The Cadillac Serviceman

MAY, 1957

© 1957 GENERAL MOTORS CORP.

Fig. 1

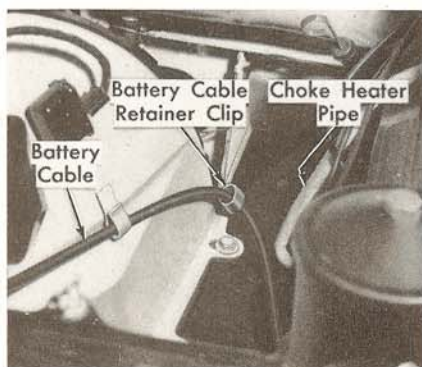
ON early model 1957 series cars, the battery cable retainer clip on the right front fender inner dust shield was incorrectly positioned. As a result, the battery cable might contact the choke heater pipe, which might burn away the insulation and cause a short circuit in the battery cable.

To remedy this condition in production, effective with Engine No. 055227, the battery retainer clip has been turned inward as illustrated in Fig. 1. This will allow more clearance between the battery cable and the choke heater pipe.

When performing any work underneath the hood on cars built previous to Engine No. 055227, Servicemen should bend the battery cable retainer clip sufficiently to obtain adequate clearance at the choke heater pipe.

Fig. 2

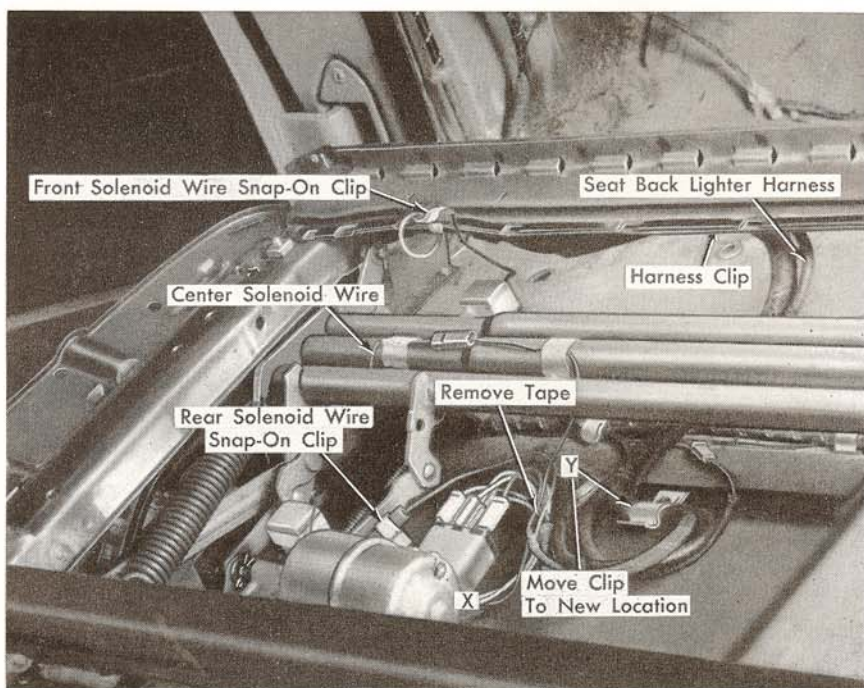
WHENEVER wiring interference is encountered in the six-way seat adjuster mechanism, or if the seat adjuster control wiring is disturbed during service operations on 1957 series 60 and 62 style cars, the following instructions should be observed:

4. The location of the wire harness clips on the floor pan should be checked. If clips are present at locations "X" and "Y", as in Fig. 2, remove clip at location "X" and move clip at location "Y" to new position, shown in Fig. 2. This new location should position the clip away from the front of the actuator motor, while keeping it in the area between the front and rear floor carpets.

1. Remove front seat assembly (Refer to Section 17, Note 85 of the 1957 Shop Manual).
2. Check to see that the rear solenoid connector is installed under snap-on clip, as shown in Fig. 2.

3. Where present, remove snap-on clip securing front solenoid wire to adjuster linkage. Tape solenoid wire and lead wire to the center torque tube, as in Fig. 2.

5. Remove tape that binds the front and rear solenoid lead wires together, for a length of 5".
6. Install seat adjuster wire harness under newly located clip "Y" on floor pan.

9. Connect harness to lead wires. Install front solenoid wire connector and snap-on clip to inner flange of seat bottom frame as illustrated in Fig. 2.

10. Operate seat assembly to the full "forward" and "up" position. Wire harness should be positioned under newly located clip "Y" on floor pan, to take up slack in wire harness between the seat and clip on floor pan.

Fig. 3

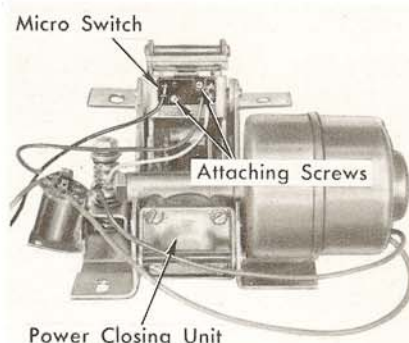
REPLACEMENT of the complete automatic deck lid lock assembly because of damage to the micro switch is no longer necessary. The micro switch is now available through the factory Parts Warehouse for service replacement. The part number of the micro switch for 1957 cars is 4902033.

An inoperative micro switch is, in most cases, due to misalignment of the deck lid or mispositioning of the deck lid lock unit. If either situation exists, the deck lid lock may not engage the lock striker properly as the deck lid is closed, resulting in damage to the switch.

To replace the switch, unsolder the wire leads at the switch, Fig. 3, and remove the two attaching screws. Install the new switch and reattach the wire leads, making certain that they are connected to the correct terminals.

After installing a new switch, check the deck lid and deck lid lock unit adjustments. Refer to Notes 108 and 111 in Section 17 of the 1957 Shop Manual.

Fig. 4

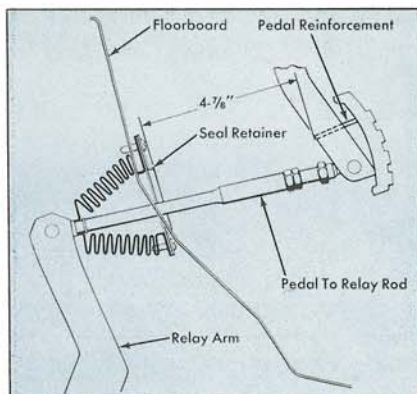
MEASUREMENT of brake pedal travel as illustrated in Fig. 8-5 of the 1957 Shop Manual is incorrect. The $4\frac{7}{8}$ " measurement between the seal retainer and the pedal reinforcement should be taken between the points indicated in Fig. 4.

Each Serviceman should correct the illustration in his copy of the Shop Manual, to assure correct measurement for this important adjustment.
